# CITY OF ALBUQUERQUE

RE: **ABQ Ride Daytona Transit Facility**  
**Conceptual Grading and Drainage Plan**  
**Engineer's Stamp Date: 5/18/17**  
**Hydrology File: J09D025**

Based on the information provided in your submittal received on 5/19/17, the Conceptual Grading and Drainage Plan is not approved for Administrative Amendment for Grading Permit and Paving Permit. The following comments must be addressed prior to approval:

ABQ RIDE DAYTONA DESIGN  
CONCEPTUAL GRADING AND DRAINAGE PLAN  
PROPOSED CONDITIONS DRAINAGE BASIN MAP

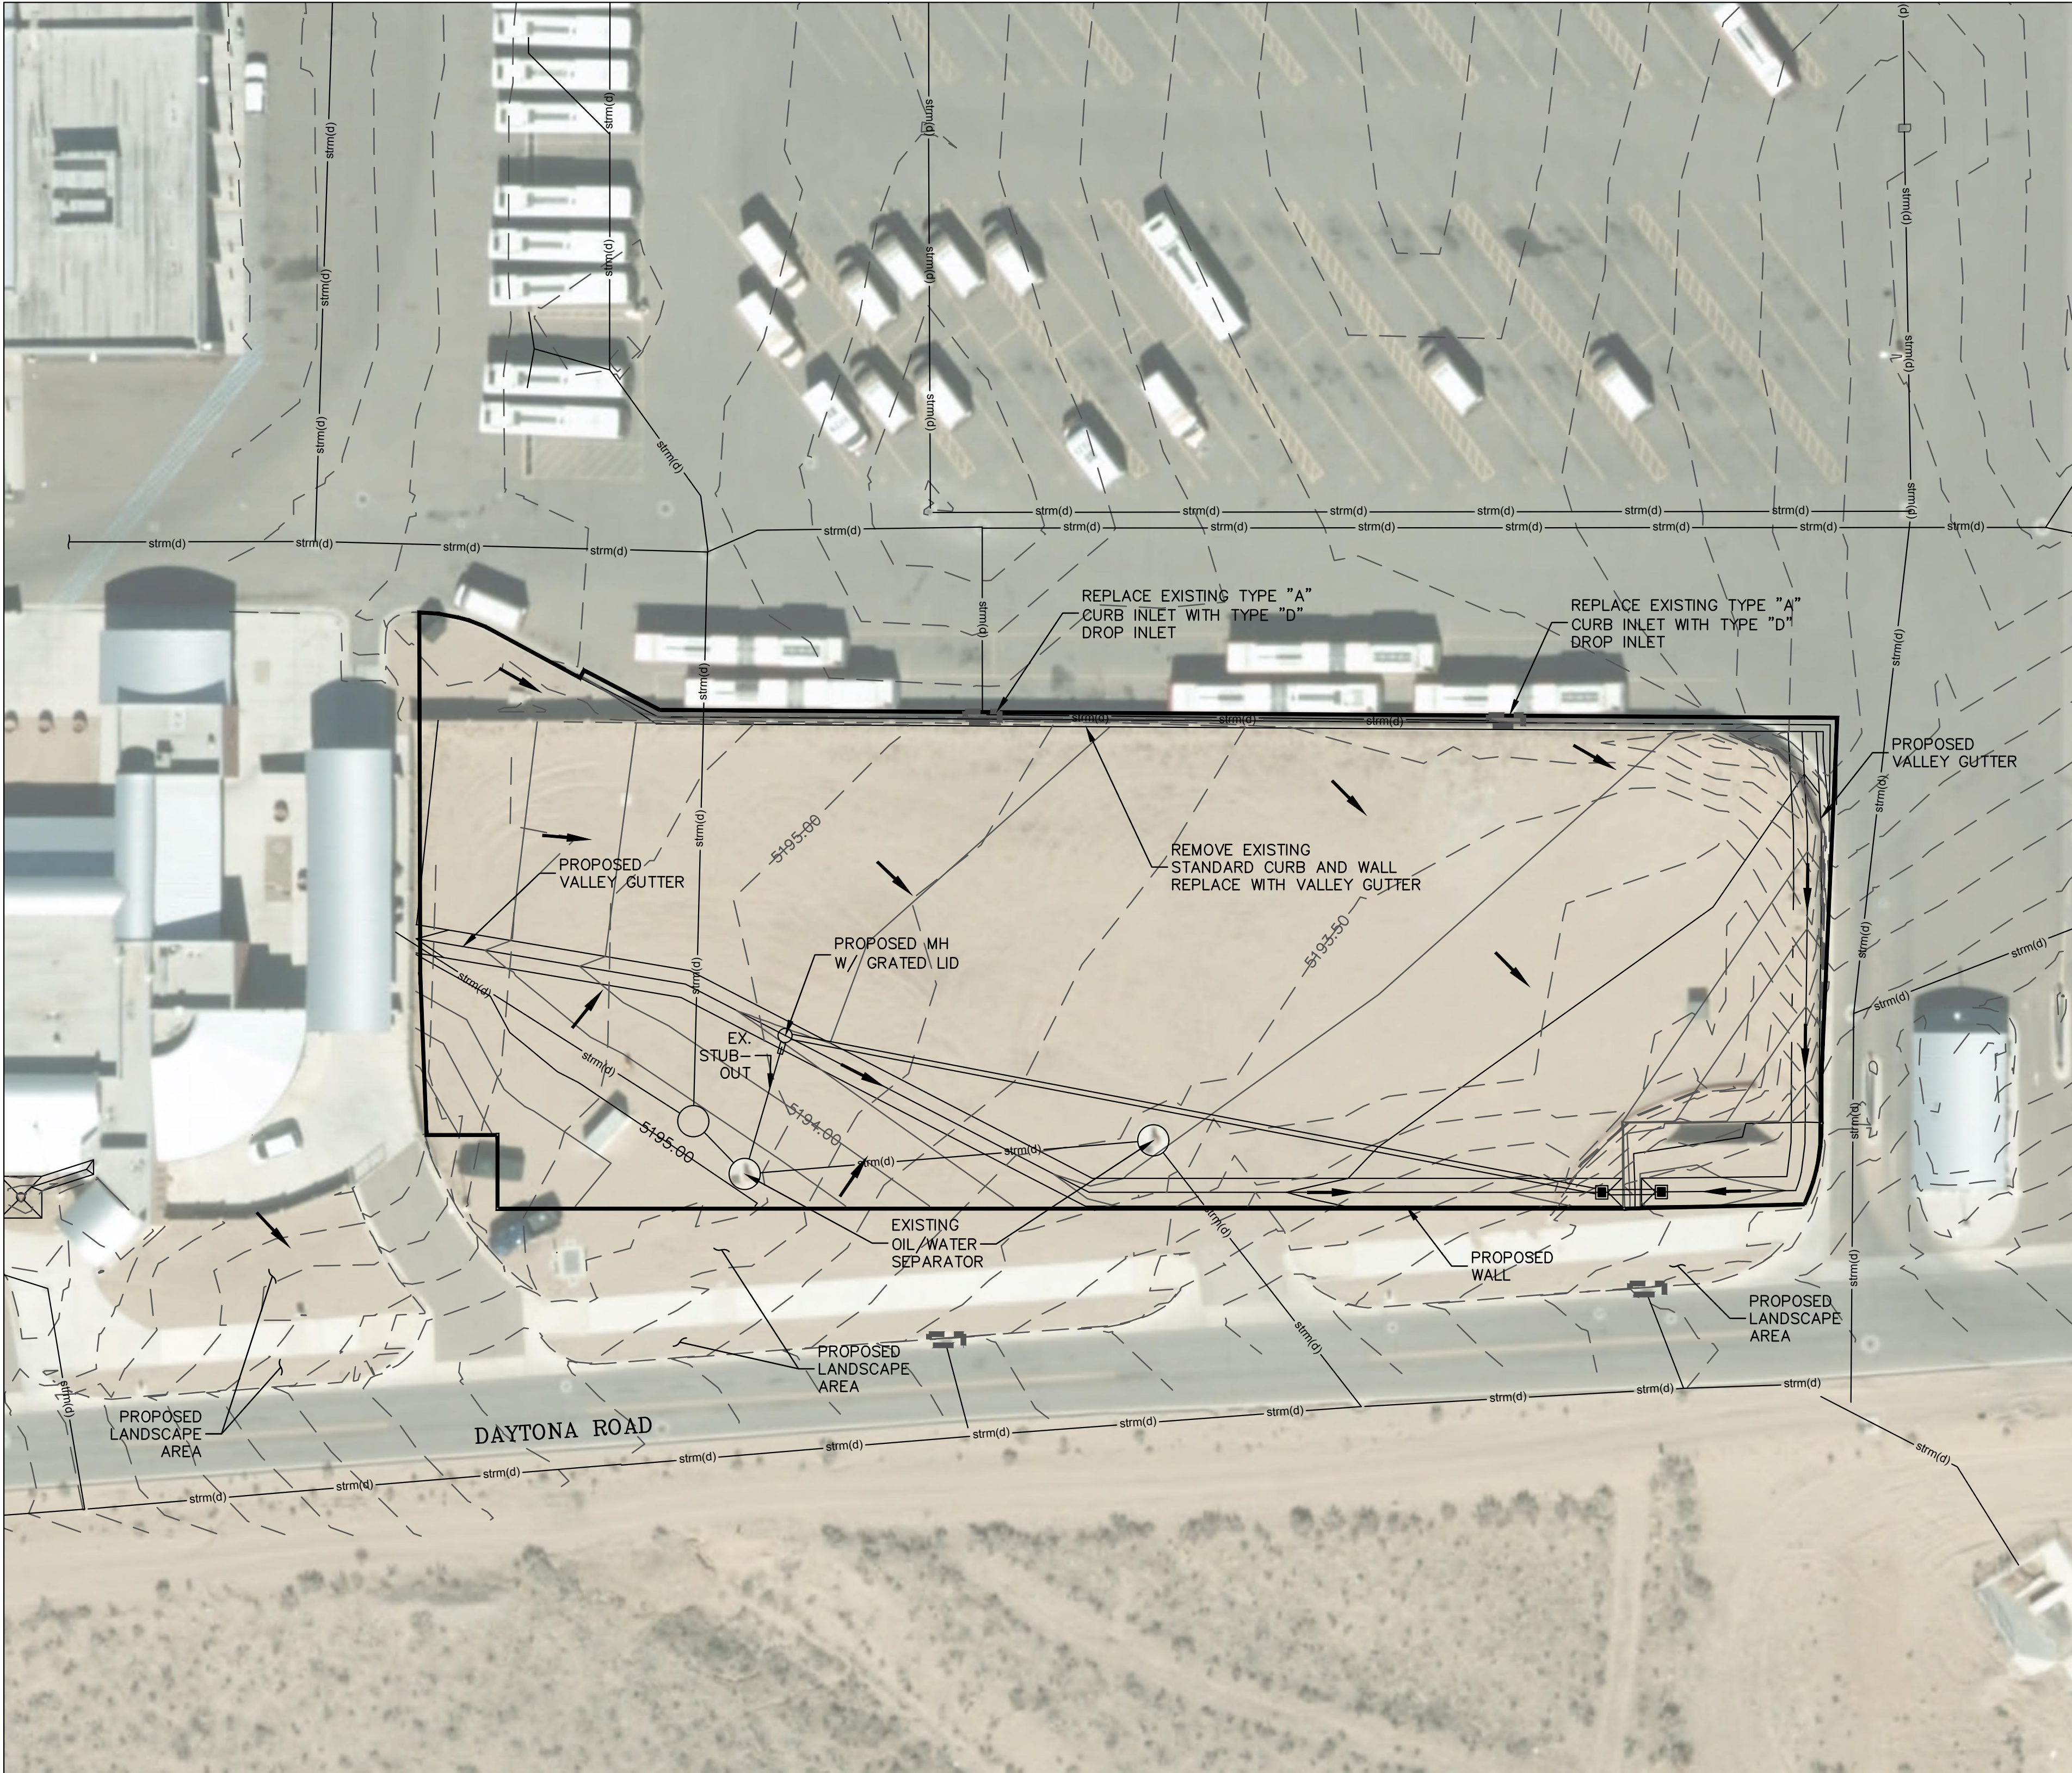
1. The storm water quality volume is not being retained on-site because this site is permitted under an industrial discharge permit requiring flows from the parking areas to be routed through the oil/water separators. The drainage narrative needs to be updated to reflect that the drainage from the new impervious parking lot is required to comply with the site's SWPPP and cannot be retained and infiltrated.
2. The depressed landscaping areas that will retain non-contaminated flows from the sidewalk areas need to be depressed with 5:1 side slopes. Additional notes regarding storm water quality swales are attached.
3. Provide invert, slope and capacity data to ensure the new storm drain will function as proposed.
4. Increase the density of existing and proposed contour labels.
